2006 Cadillac STS-V: Service Bulletin: #07-07-30-002: 6L80 Automatic Transmission Busy Shifting, MIL Illuminated, DTC P1751 Set

#07-07-30-002: 6L80 Automatic Transmission Busy Shifting, MIL Illuminated, DTC P1751 Set (Replace Control Valve Body Spacer Plate) - (Jan 30, 2007)

Subject:	6L80 Automatic Transmission Busy Shifting, MIL Illuminated, DTC P1751 Set (Replace Control Valve Body Spacer Plate)
Models:	2006 Cadillac XLR-V, STS-V 2006 Chevrolet Corvette 2007 Cadillac Escalade, Escalade ESV, Escalade EXT 2007 GMC Yukon Denali, Yukon Denali XL Built Prior to December 2006 with 6L80 (RPO MYC) Automatic Transmission

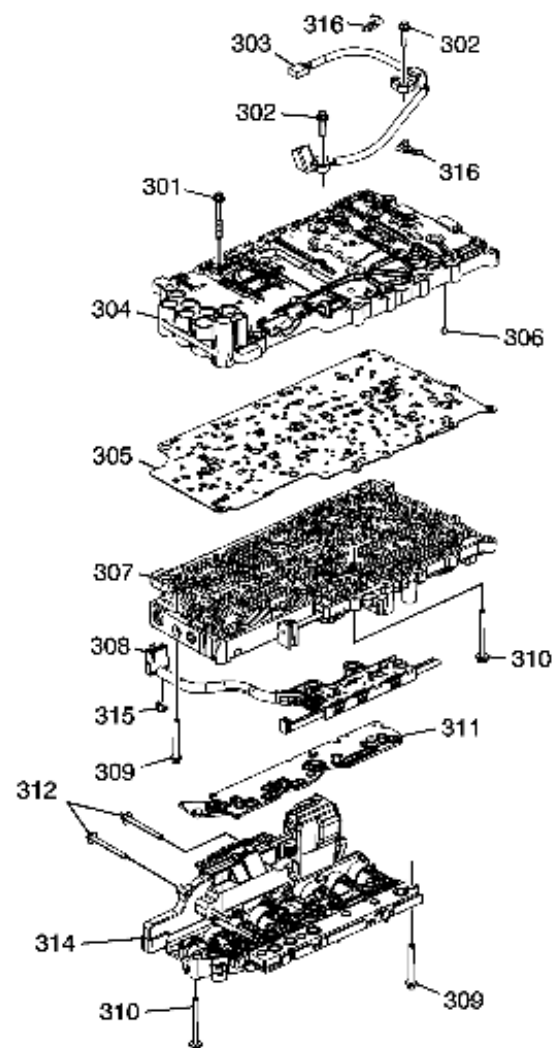
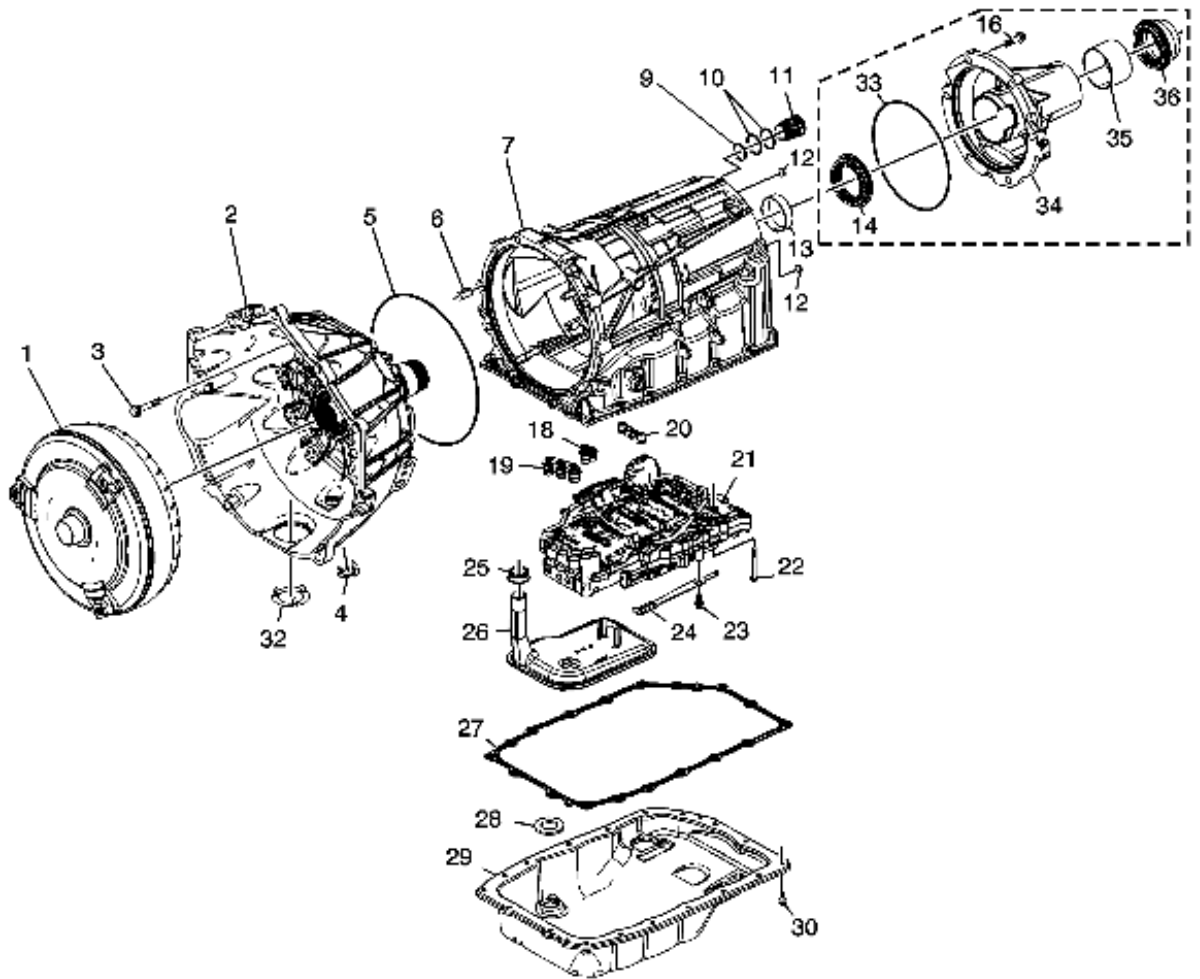
This condition may be caused by an undersized hole or debris in the control valve body spacer plate (305).

To correct this condition the control valve body spacer plate (305) must be replaced. The electrical connector seals (9, 10), fluid pump seals (18, 19), center support seal (20) and the filter plate assembly (311) should also be replaced. These parts are included in the filter plate kit listed below.

Changes to the control valve body spacer plate were implemented November 4, 2006 in transmission assemblies to prevent this condition.
